RE: Broken Arrow Investments, LLC – Derr Pit – Technical Revision No. 8 Adequacy Review 2 Response – File No. M-2008-017

Broken Arrow Investments, LLC has received the Division's Adequacy Review 2 of the Technical Revision No. 8 Request letter dated April 19, 2023. Below are the comments and the corresponding responses that we have provided to address the comments.

Adequacy Review 2 Comments

JT-Derr 2020 Red Sheet:

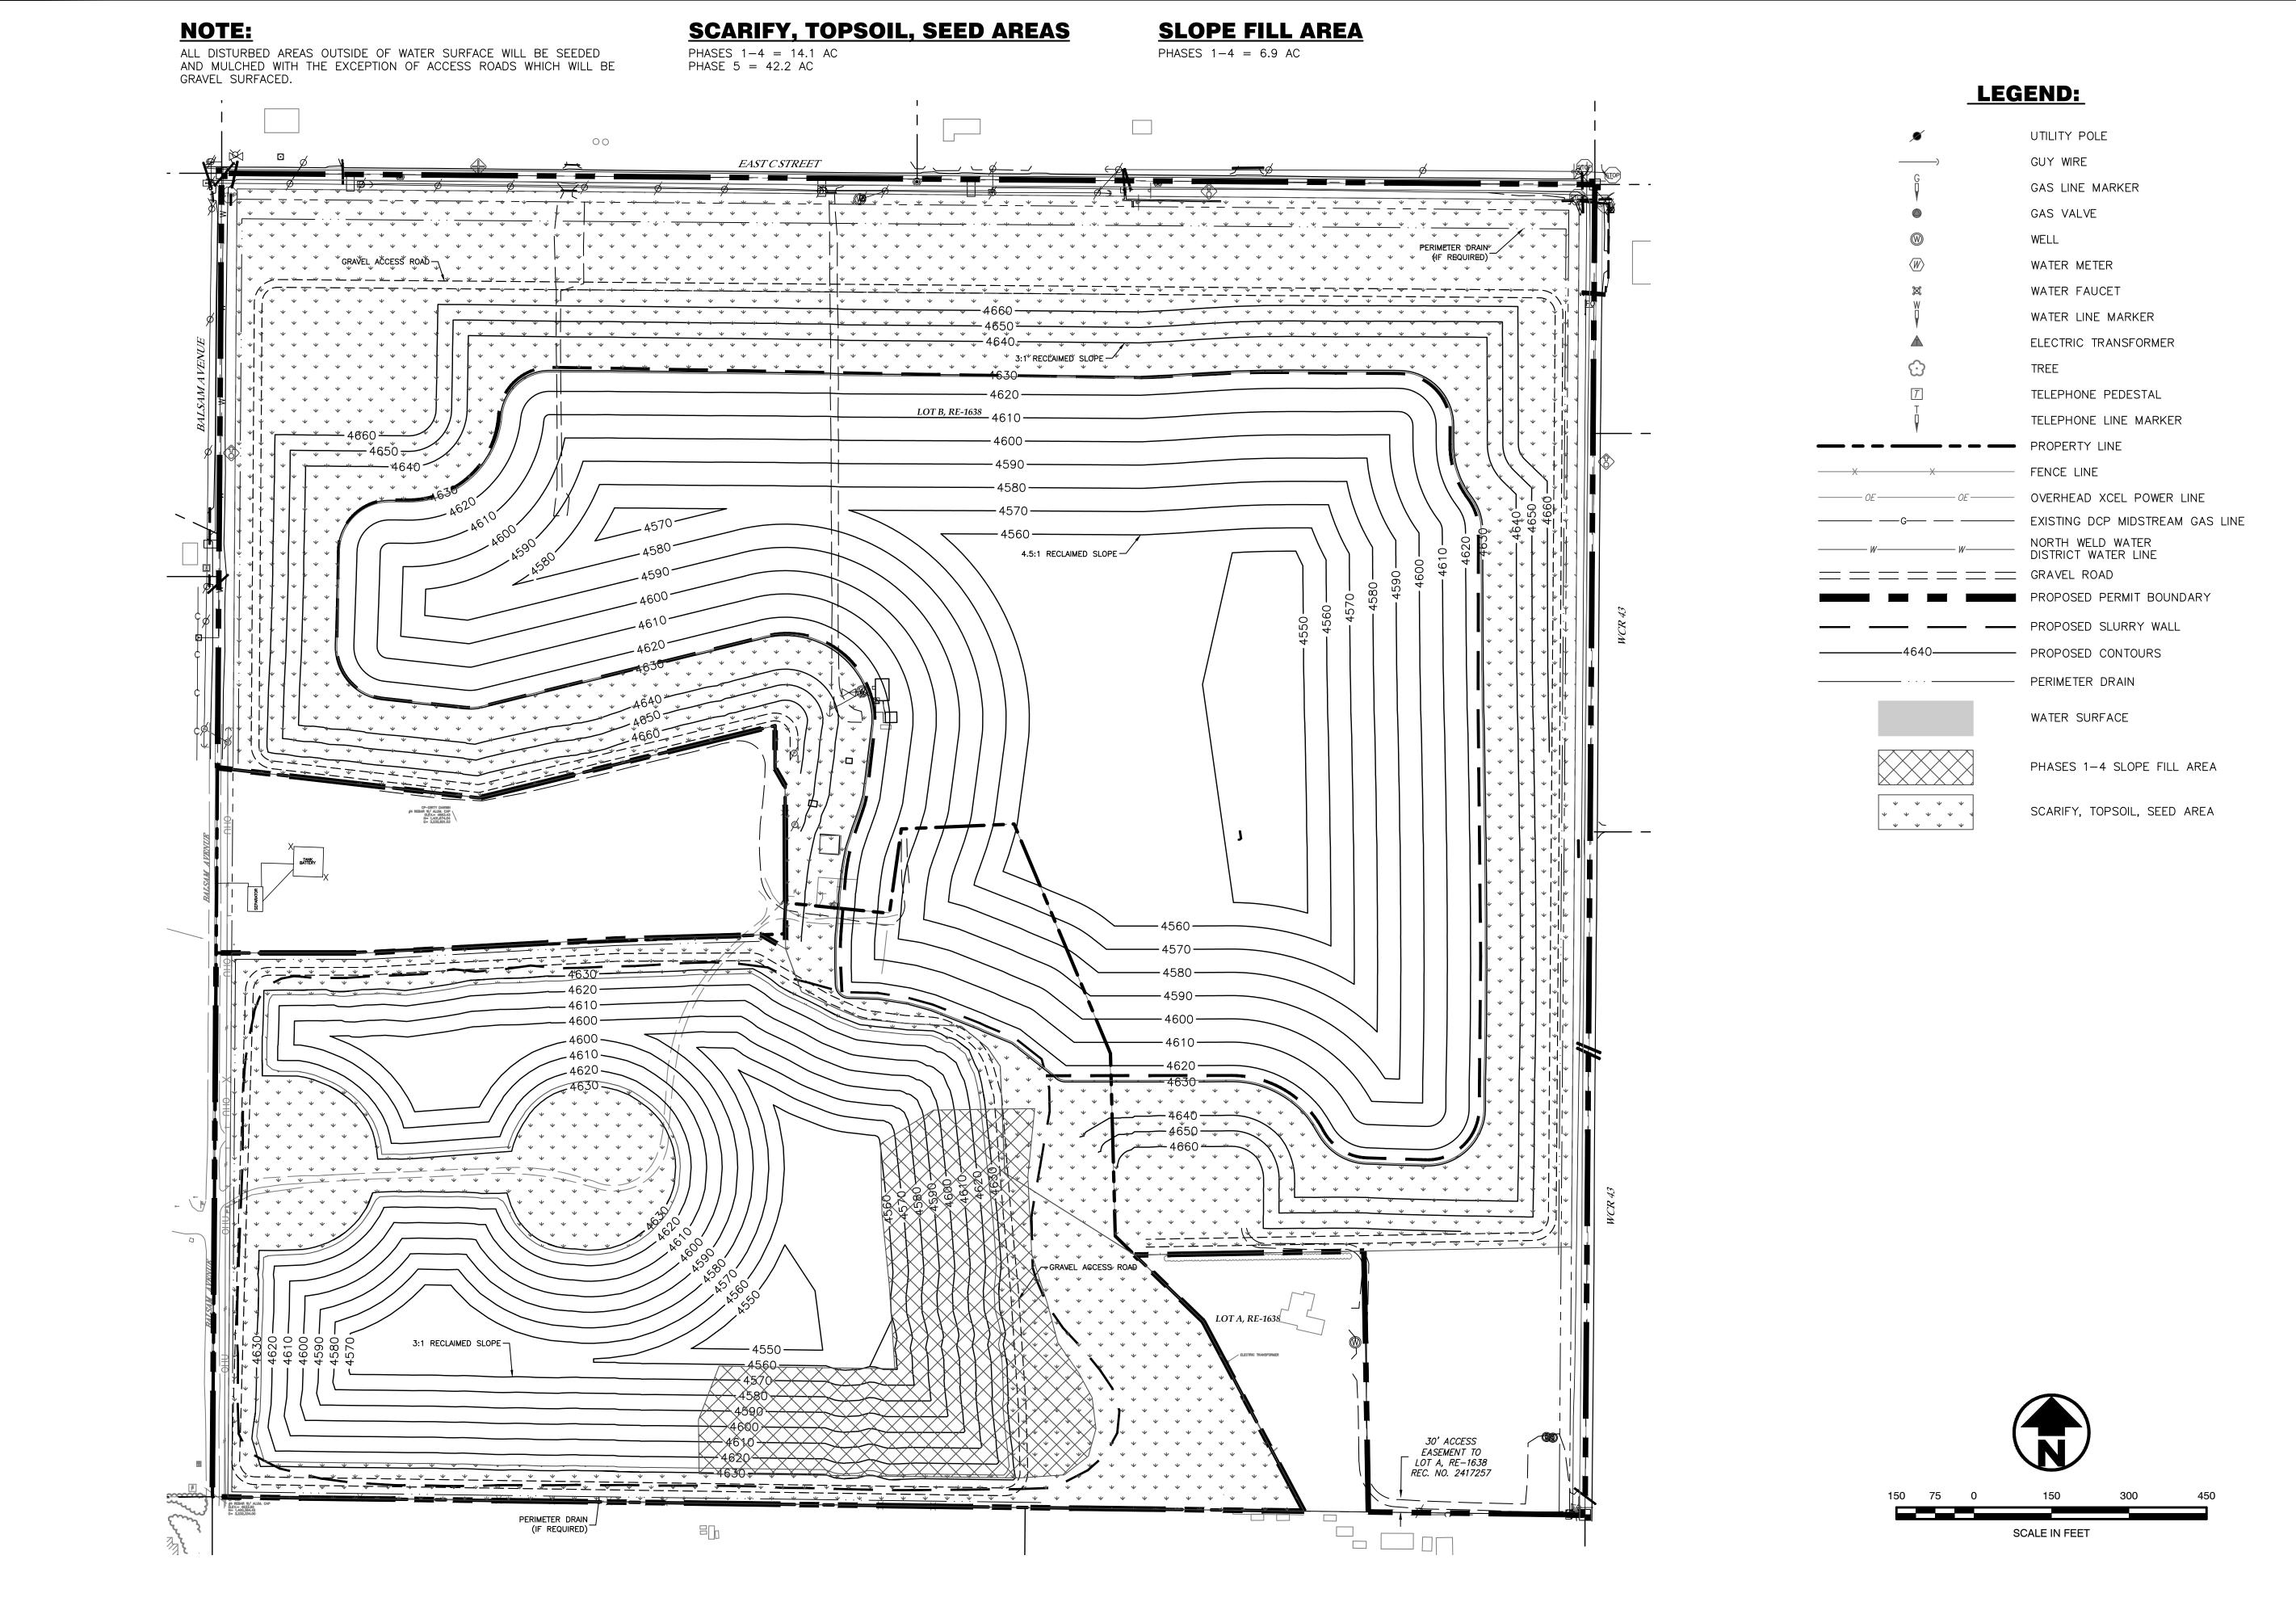
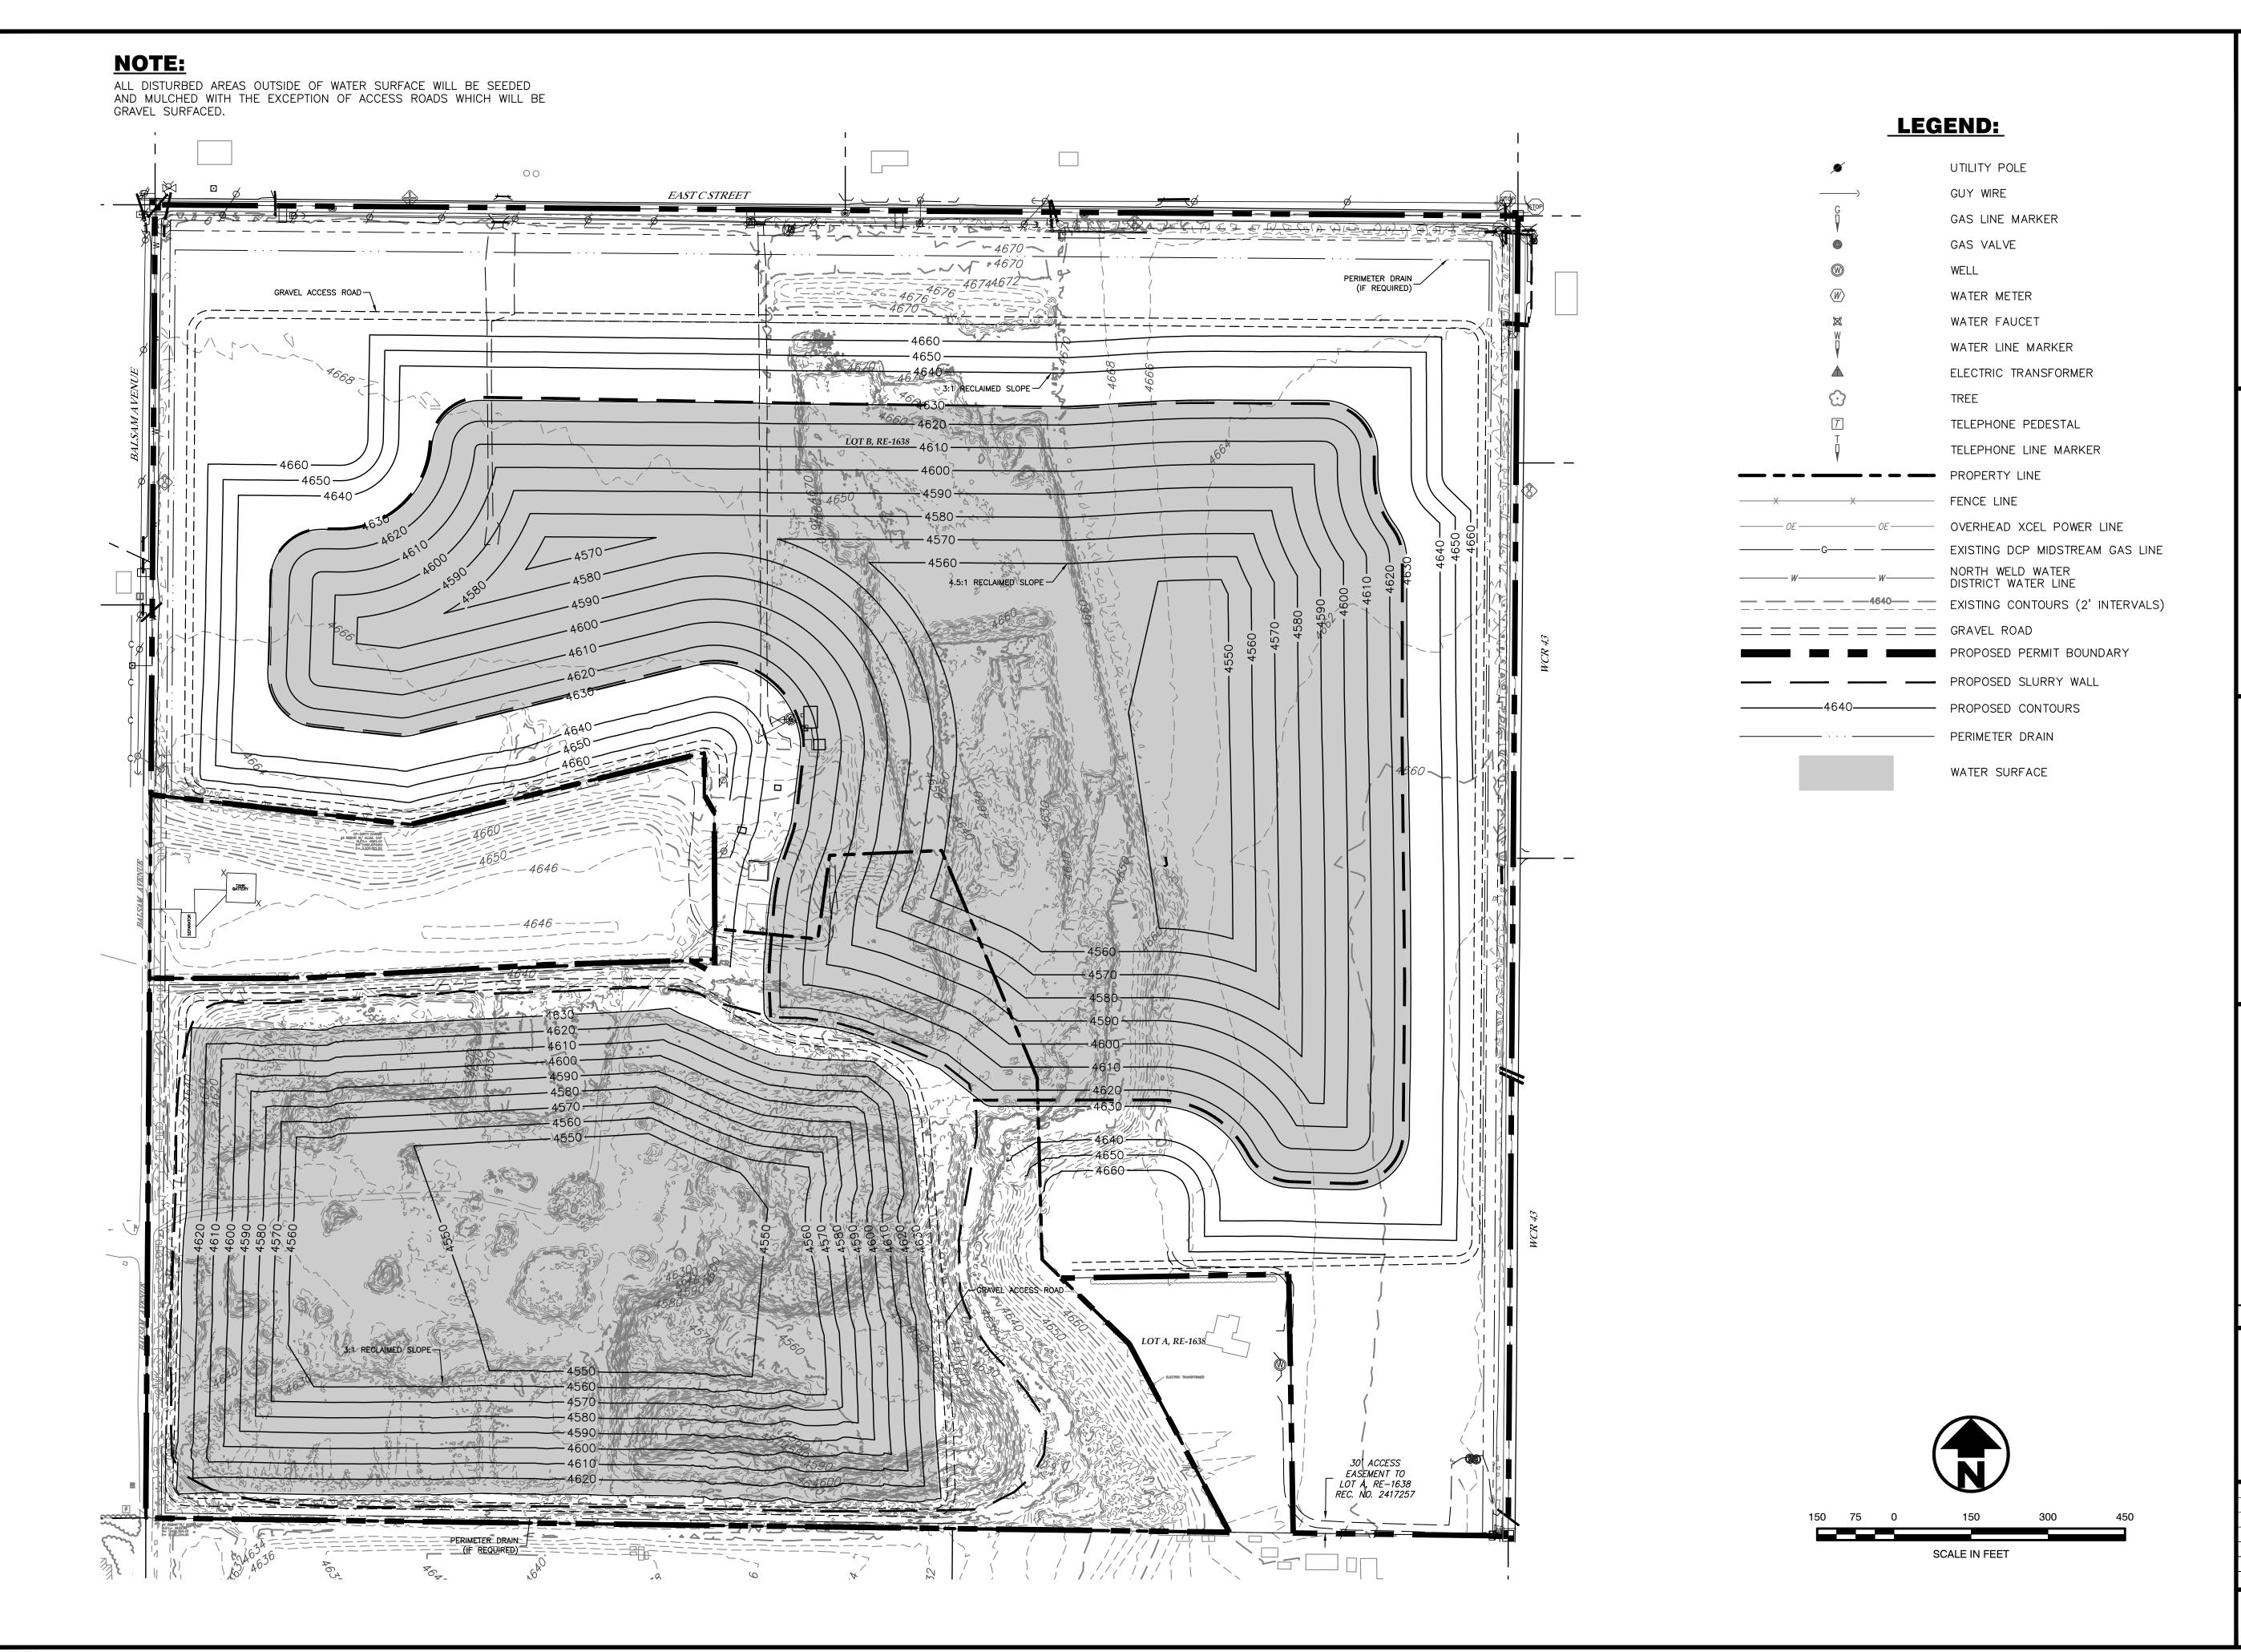
- 3. Please provide a reclamation plan map(s) that illustrates the following tasks by area:
 - a) Phases 1-4 acres where 6" topsoil will be replaced, scarified, and revegetated, including area of reservoir above proposed waterline. (CIRCES software calculates revegetation cost based on acres, seed mix, tilling, mulch/fertilizer, and anticipated failure/re-seed rate)
 - b) Phases 1-4 acres of 3:1 interior slope that will need to be compacted and graded below waterline.
 - c) Phase 5 perimeter acres that will need to have topsoil replaced, graded and seeded above water line. DRMS assumes that the entire area within Phase 5a will need to have topsoil replaced and reseeded for bonding purposes.

Response: An updated Reclamation Plan Map has been provided with the attachments

to this letter providing the location of acres where the 6" topsoil will be replaced, scarified and revegetated, Phases 1-4 acres of 3:1 interior slope that will need to be compacted and graded, and Phase 5 perimeter acres that will need to have topsoil replaced, graded and seeded. Acknowledged that Phase 5a area bonding is for all area to be re-seeded.
